TECH NOTE H

ISSUE DATE: 10-Dec-04
EXEDY REF: H
REVISED: 15-Aug-05

**GMH/NISSAN CLUTCH KIT NSK-6336,
NSK-6863, NSK- 6921**

PROBLEM: EXCESSIVE FREE TRAVEL AND CLUTCH NON RELEASE

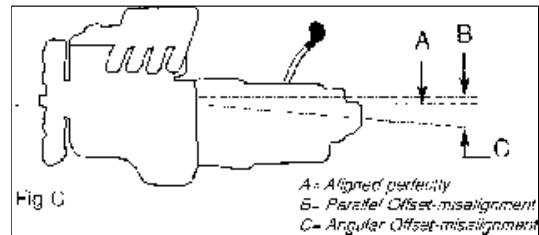
2. Excessive free travel

Note: In the event these procedures are followed and no release of drive plate is obtained, then use the following procedures.

- a) Remove clutch cable bracket (refer Fig A)
- b) Measure and drill two mounting holes approximately 5mm from existing holes towards outer edge. (1)

Holes must not be elongated (i.e. filed longer) as this may lead to eventual failure. The bracket must be drilled concentrically parallel to the original holes.

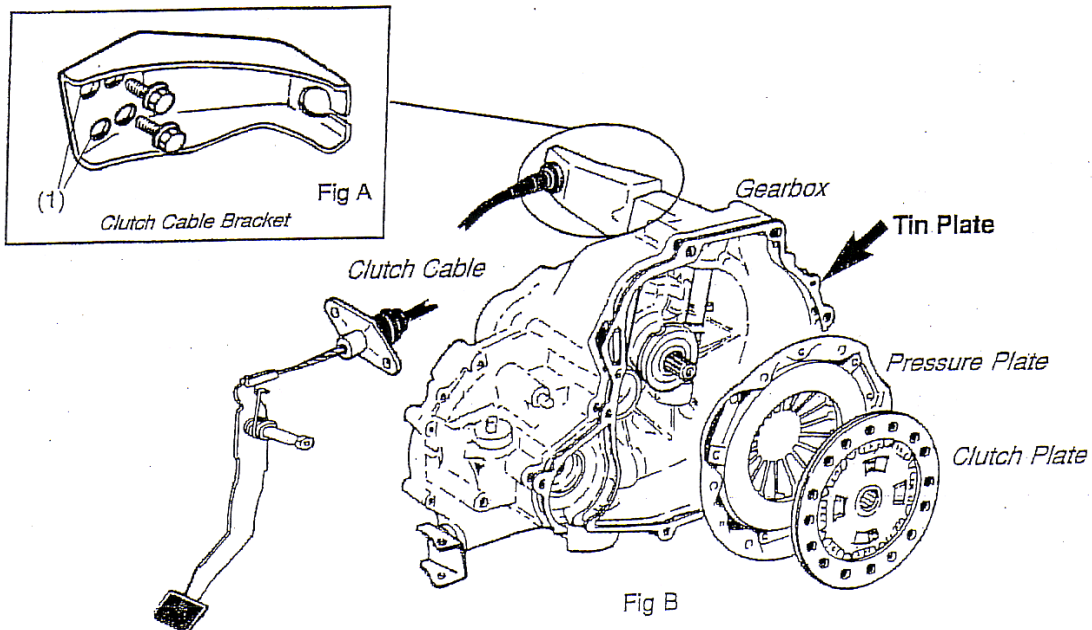
PROBLEMS: PREMATURE CLUTCH FAILURE CAUSED BY MISALIGNMENT (FIG C).

Any misalignment will result in damage of side plate, springs and hub of the clutch disc. This will lead to total clutch failure.

The tin plate located between the motor and the gearbox surfaces (as shown below with use of arrow Fig B) must be cleaned and aligned perfectly on the dowel pins and bolts when mating gearbox to motor.
